Quad Cities Nuclear Power Station, Units 1 and 2
Renewed Facility Operating License Nos. DPR-29 and DPR-30
NRC Docket Nos. 50-254 and 50-265

Subject: Third Six-Month Status Report in Response to March 12, 2012 Commission Order Modifying Licenses with Regard to Requirements for Mitigation Strategies for Beyond-Design-Basis External Events (Order Number EA-12-049)

**Third Six-Month Status Report for the Implementation of Order EA-12-049, Order
Modifying Licenses with Regard to Requirements for Mitigation Strategies for Beyond-
Design-Basis External Events**

MAAP Calculation of RPV Pressure During RPV Depressurization

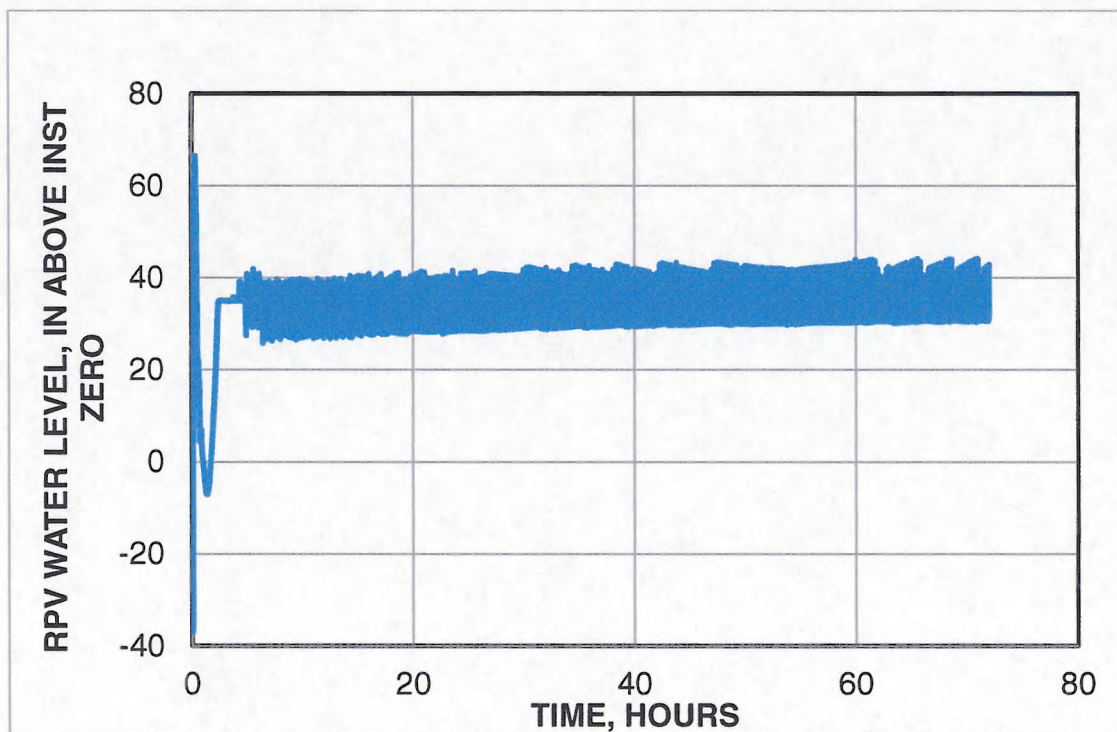
3.2.1.1.B The collapsed level must remain above Top of Active Fuel (TAF) and the cool down rate must be within technical specification limits in the MAAP4 analysis.

The Quad Cities Integrated Plan states that the operators would commence a cooldown of the RPV after the RPV water level reaches +40" at a rate of 80°F/hr which is within the technical specifications limit of 100°F/hr. The following plot of the RPV pressure from the MAAP analysis uses a cooldown initiation setpoint of +40" water level in the RPV.

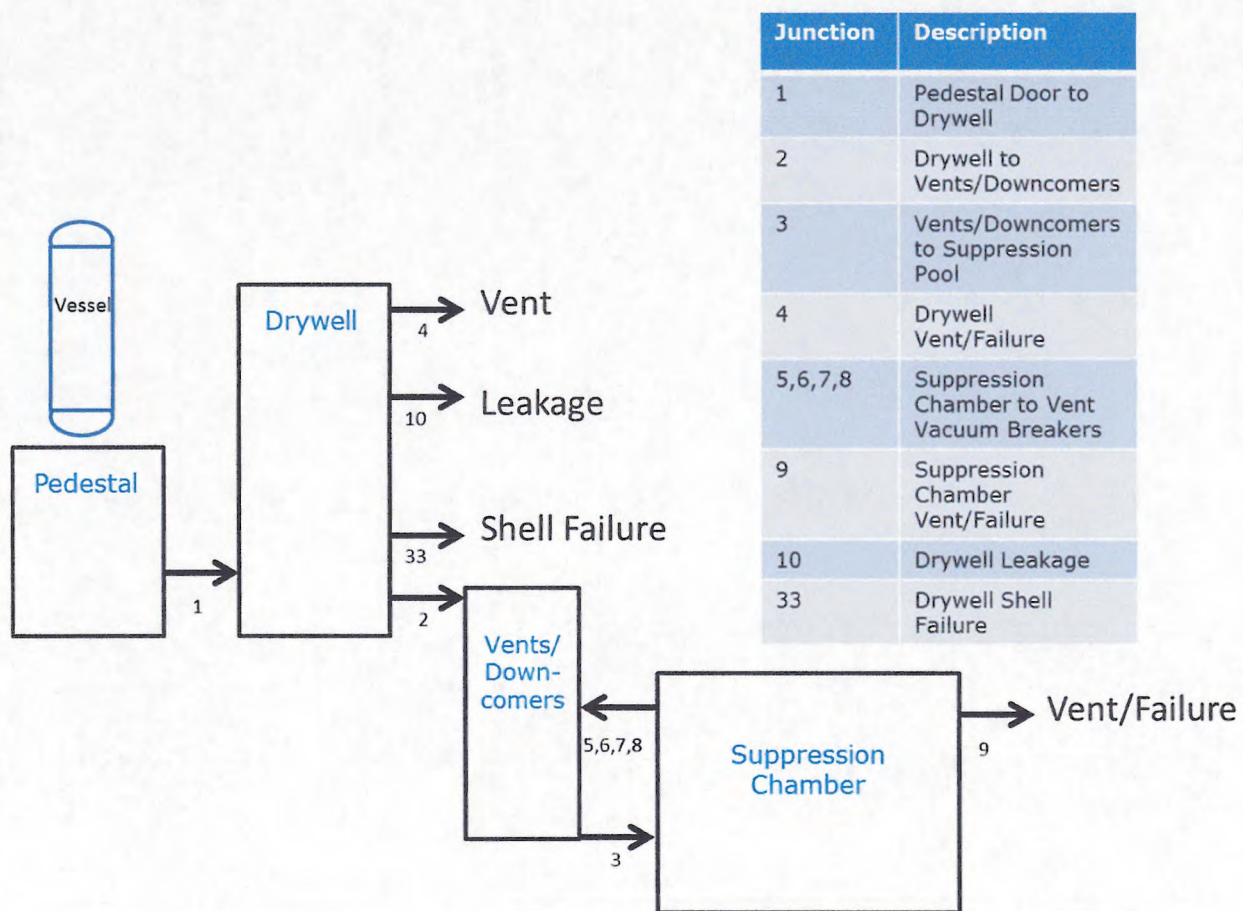
3.2.1.1.D In using MAAP4, the licensee must identify and justify the subset of key modeling parameters cited from Tables 4-1 through 4-6 of the "MAAP4 Application Guidance, Desktop Reference for Using MAAP4 Software, Revision 2" (Electric Power Research Institute Report 1 020236). *This should include response at a plant-specific level regarding specific coding options and parameter choices for key models that would be expected to substantially affect the ELAP analysis performed for that licensee's plant. Although some suggested key phenomena are identified below, other parameters considered important in the simulation of the ELAP event by the vendor / licensee should also be included.*

- a. Nodalization
- b. General two-phase flow modeling
- c. Modeling of heat transfer and losses
- d. Choked flow
- e. Vent line pressure losses
- f. Decay heat (fission products / actinides / etc.)

- a. The reactor vessel nodalization is fixed by the MAAP code and cannot be altered by the user, with the exception of the detailed core nodalization. The Quad Cities MAAP 4.0.5 parameter file divides the core region into 5 equal volume radial regions (See NCHAN) and 13 axial regions (See NAXNOD). The axial nodalization represents 25 equal-sized fueled nodes (see NROWS), 1 unfueled node at the top (see NNFT), and 2 unfueled nodes at the bottom (see NNFB). The figure below, taken from the MAAP Users Manual, illustrates the vessel nodalization scheme.

Containment nodalization is defined by the user. The standard nodalization scheme is used in the Quad Cities MAAP 4.0.5 parameter file and represents the following individual compartments:

1. Reactor pedestal region
2. Drywell
3. Drywell vents to torus
4. Torus (Wetwell)
